SERVICE BULLETIN**FUSELAGE - INSTALLATION OF DRAG REDUCING MICROVANES ON C-130J AIRCRAFT AFT FUSELAGE****1. PLANNING INFORMATION****A. EFFECTIVITY**

This Service Bulletin provides the instructions for installing the two sets of ten microvanes on the left and right hand sides of the C-130J aft fuselage using specially designed tooling.

3368269-1-LF/3368269-2-LF Locating Fixture Assembly and Location
Figure 1, Sheet 1 of 2

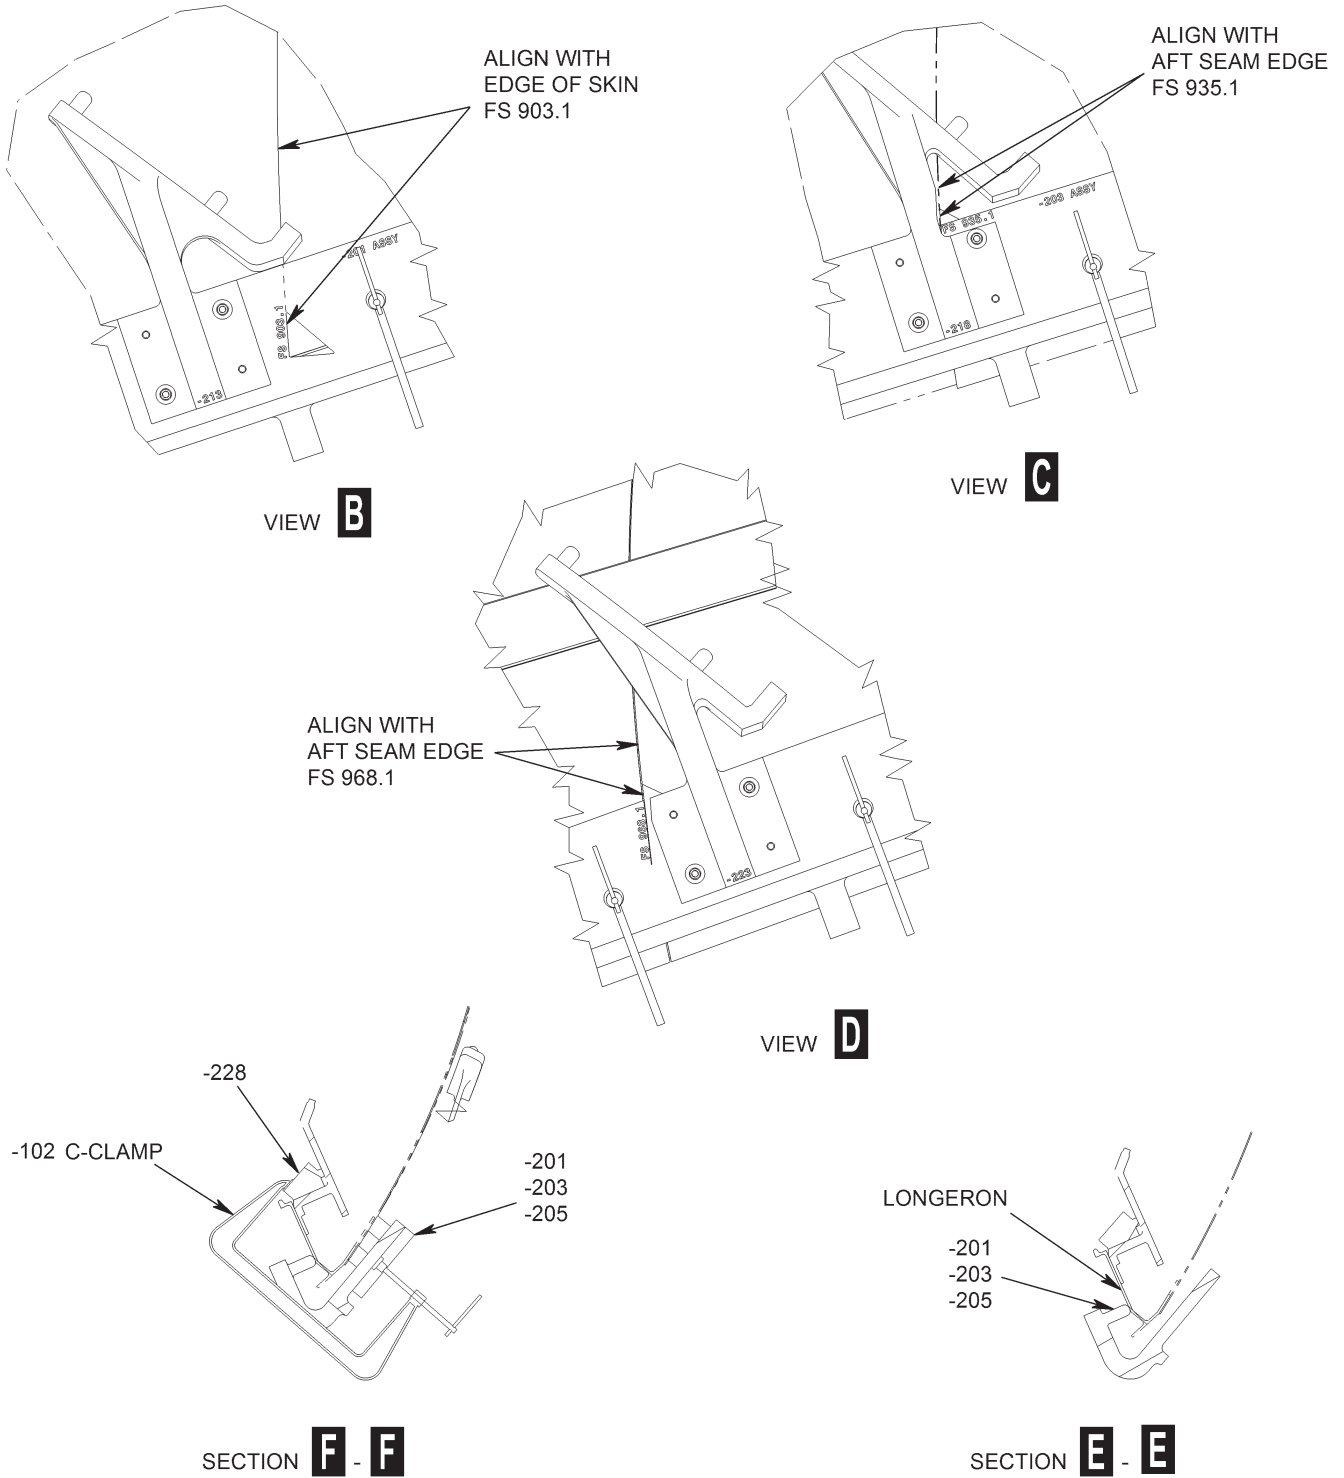
- E. Install 3368269-1 Microvanes Installation, Kit on aircraft aft-body LHS as follows:
 - (1) Assemble and locate 3368269-1-LF Locating Fixture on aircraft. For assembly, location and tooling instruction see Figure 1, Sheet 1 and Sheet 2.

- F. Install 3368269-2 Microvanes Installation, Kit on aircraft aft-body RHS as follows:
- (1) Assemble and locate 3368269-2-LF Locating Fixture tool on aircraft. See Figure 1, Sheet 1 and Sheet 2.

Vane Installation on 3368269-1-LF/3368269-2-LF Locating Fixture
Figure 2

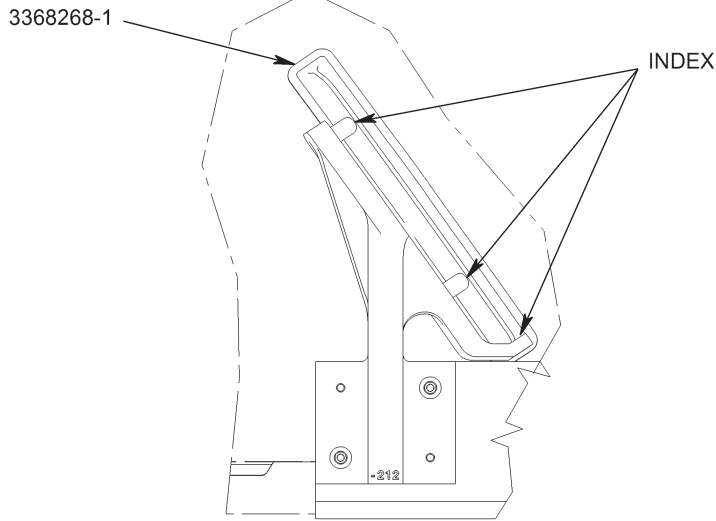
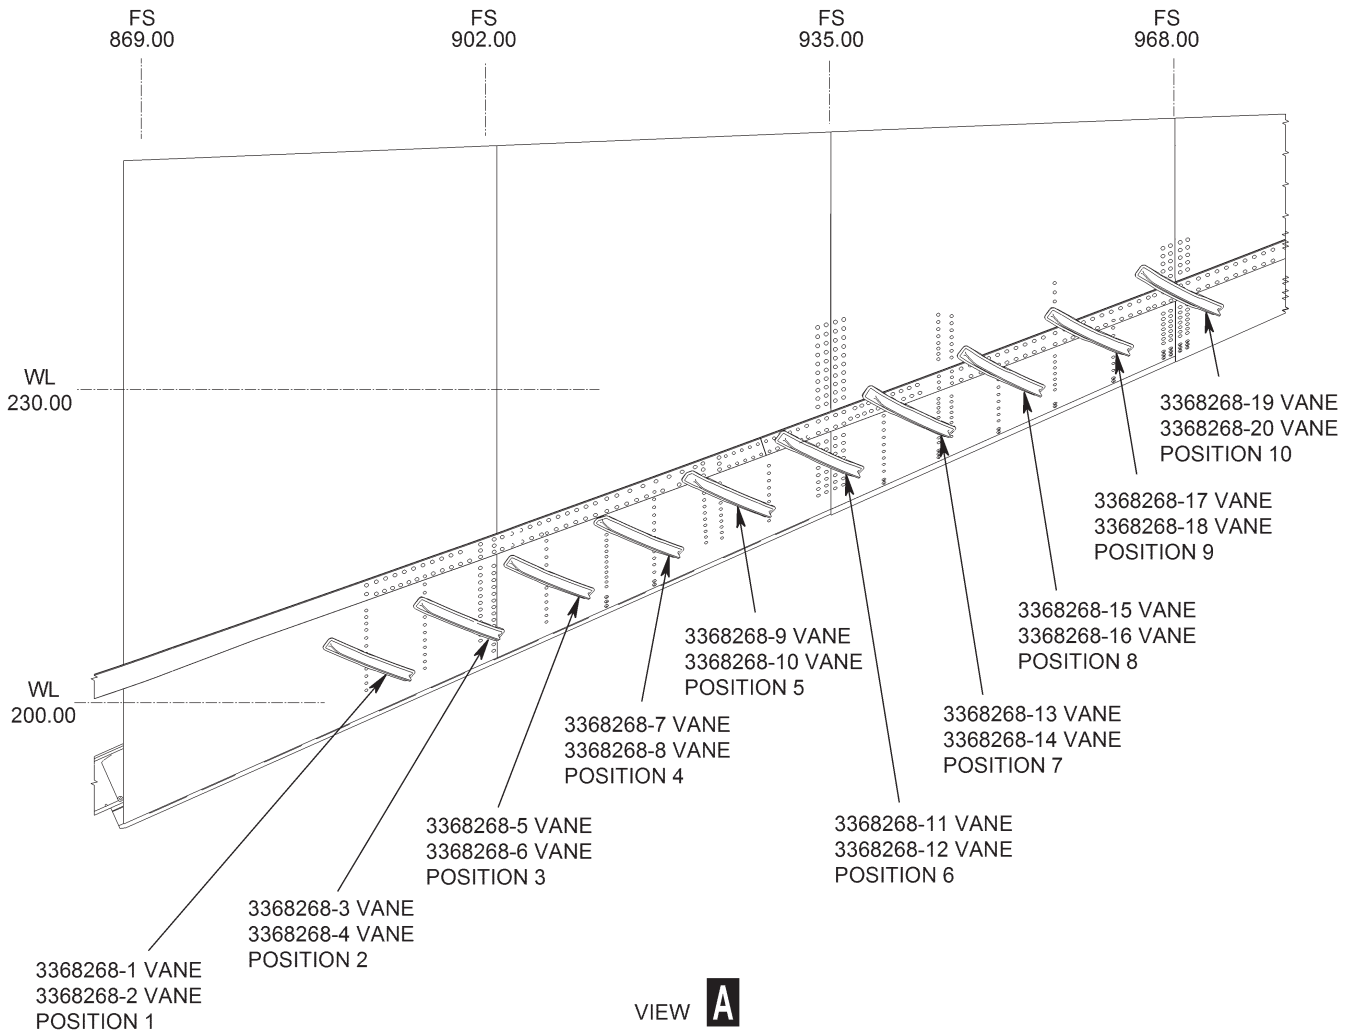
- (2) Temporarily locate 3368268-1/-3/-5/-7/-9/-11/-13/-15/-17/-19 Microvanes using 3368269-1-LF Locating Fixture and 3368270-401-TSUD. See Figure 2 and Figure 3.

- (10) Locate 3368268-1/-3/-5/-7/-9/-11/-13/-15/-17/-19 Microvanes using 3368269-1-LF Locating Fixture. Press microvanes onto aircraft using hand pressure not to exceed 5 lbs. Ensure continuous sealant squeeze-out along the microvane EOP. Clean excess squeeze-out with ASTM D 770 Isopropyl Alcohol. See Figure 2 and Figure 3.

- (2) Temporarily locate 3368268-2/-4/-6/-8/-10/-12/-14/-16/-18/-20 Microvanes using 3368269-2-LF Locating Fixture and 3368270-401-TSUD See Figure 2 and Figure 3.

- (10) Locate 3368268-2/-4/-6/-8/-10/-12/-14/-16/-18/-20 Microvanes using 3368269-2-LF Locating Fixture. Press microvanes onto aircraft using hand pressure not to exceed 5 lbs. Ensure continuous sealant squeeze-out along the microvane EOP. Clean excess squeeze-out with ASTM D 770 Isopropyl Alcohol. See Figure 2 and Figure 3.

3369284-1-LF/3369284-2-LF Locating Fixture Assembly and Location
Figure 4, Sheet 1 of 2

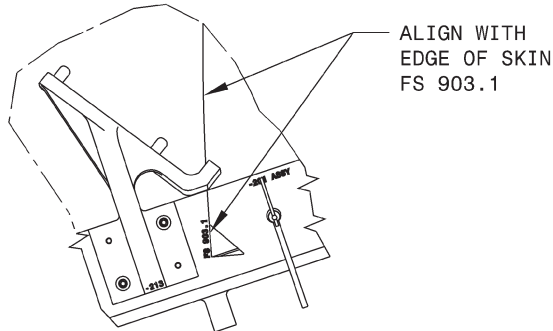
- G. Install 3369284-1 Microvanes Installation, Kit on aircraft aft-body LHS as follows:
- (1) Assemble and locate 3369284-1-LF Locating Fixture on aircraft. For assembly, location and tooling instruction see Figure 4, Sheet 1 and Sheet 2.

- H. Install 3369284-2 Microvanes Installation, Kit on aircraft aft-body RHS as follows:
- (1) Assemble and locate 3369284-2-LF Locating Fixture tool on aircraft. See Figure 4, Sheet 1 and Sheet 2.

Vane Installation on 3369284-1-LF/3369284-2-LF Locating Fixture Assembly
Figure 5

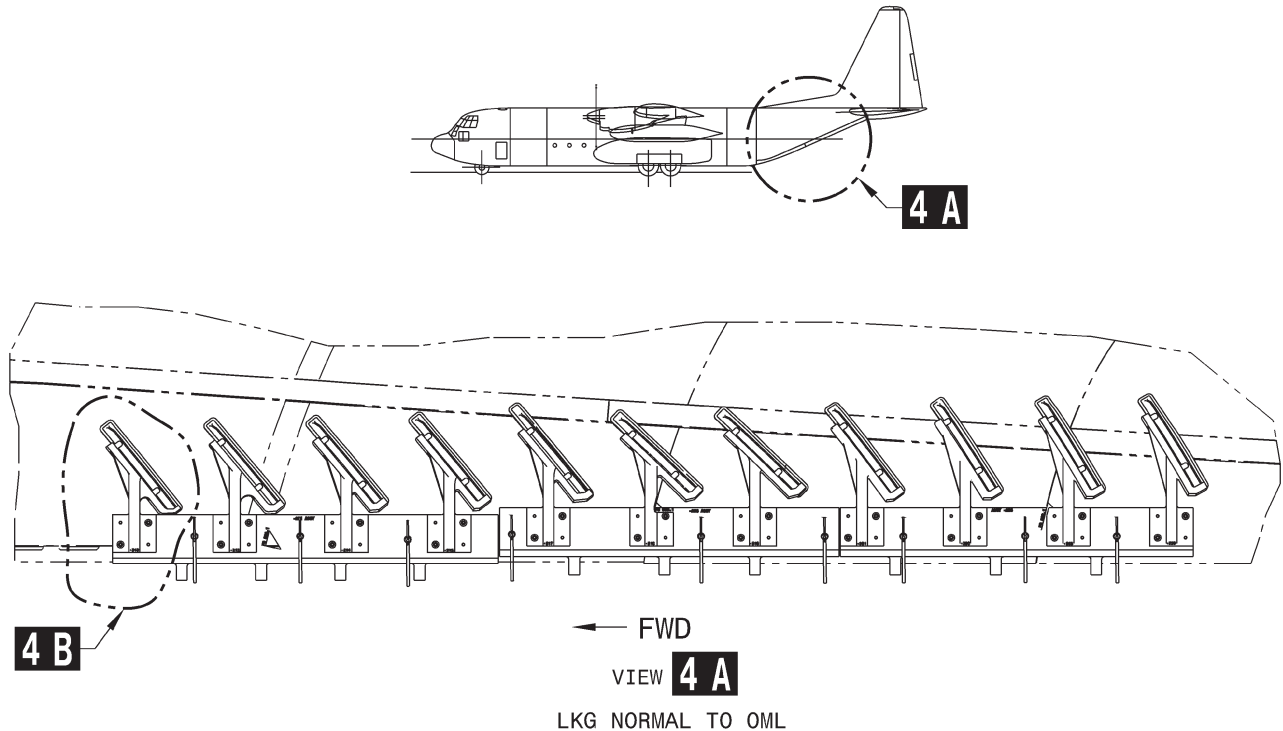
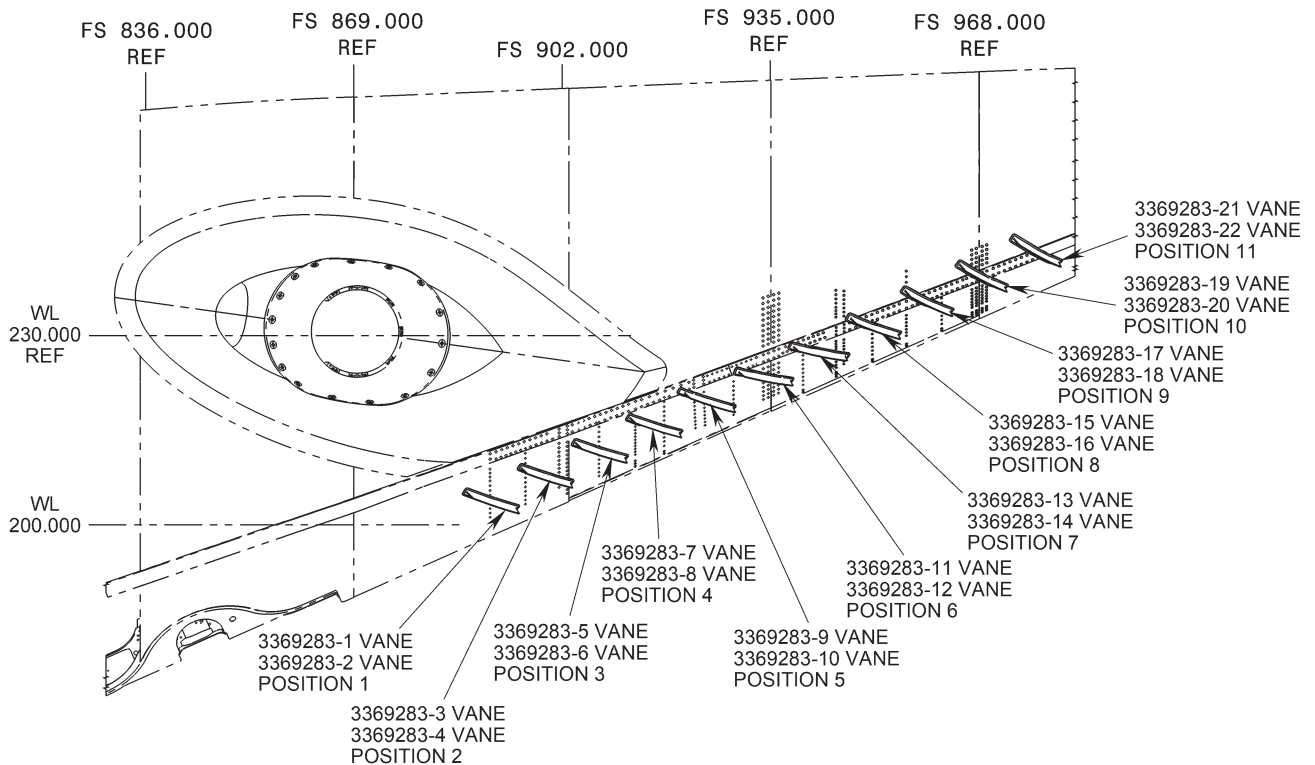
- (2) Temporarily locate 3369283-1/-3/-5/-7/-9/-11/-13/-15/-17/-19/-21 Microvanes using 3369284-1-LF Locating Fixture and 3329284-1/-2-TSUD. See Figure 5 and Figure 6.

- (10) Locate 3369283-1/-3/-5/-7/-9/-11/-13/-15/-17/-19/-21 Microvanes using 3369284-1-LF Locating Fixture. Press microvanes onto aircraft using hand pressure not to exceed 5 lbs. Ensure continuous sealant squeeze-out along the microvane EOP. Clean excess squeeze-out with ASTM D 770 Isopropyl Alcohol. See Figure 5 and Figure 6.

- (2) Temporarily locate 3369283-2/-4/-6/-8/-10/-12/-14/-16/-18/-20/-22 Microvanes using 3369284-2-LF Locating Fixture and 3329284-1/-2-TSUD. See Figure 5 and Figure 6.

- (10) Locate 3369283-2/-4/-6/-8/-10/-12/-14/-16/-18/-20/-22 Microvanes using 3369284-2-LF Locating Fixture. Press microvanes onto aircraft using hand pressure not to exceed 5 lbs. Ensure continuous sealant squeeze-out along the microvane EOP. Clean excess squeeze-out with ASTM D 770 Isopropyl Alcohol. See Figure 5 and Figure 6.
